MU Fashion Ltd.

09 June 2022

Buildings Information

RC column in stair-2 (250 mm X 250 mm)

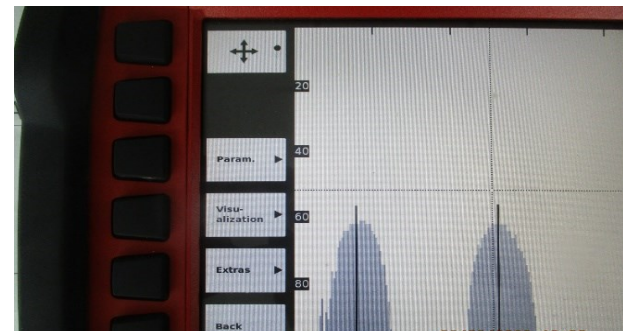
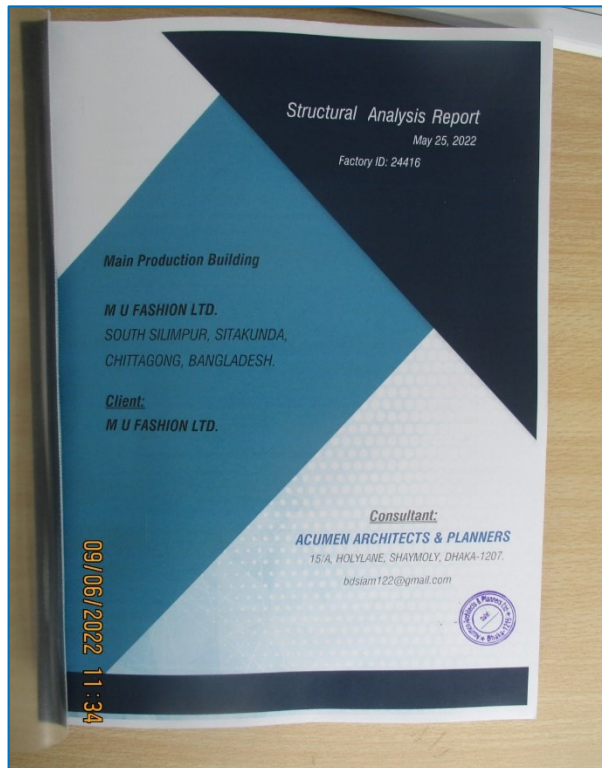
Vertical load path of the additional column

A load bearing RC column found in the marked staircase. No foundation system and load path observed of the column. Building engineer is required to check the vertical load path of the column.

2 no's re-bar found in each side

Lack of lateral stability of the roof shed

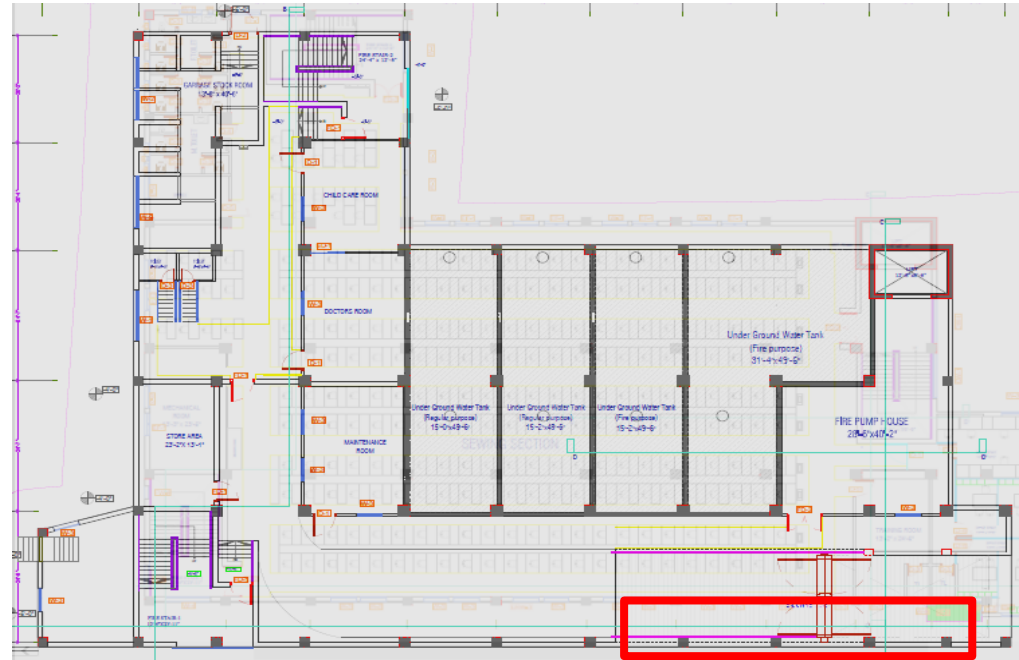
Poor connection details observed, truss welded with column re-bar. Apparently inadequate truss member and lack of lateral stability system (no bracing and compression strut). Building engineer to check the connection & member adequacy and stability of the lightweight roof structure against lateral loading.
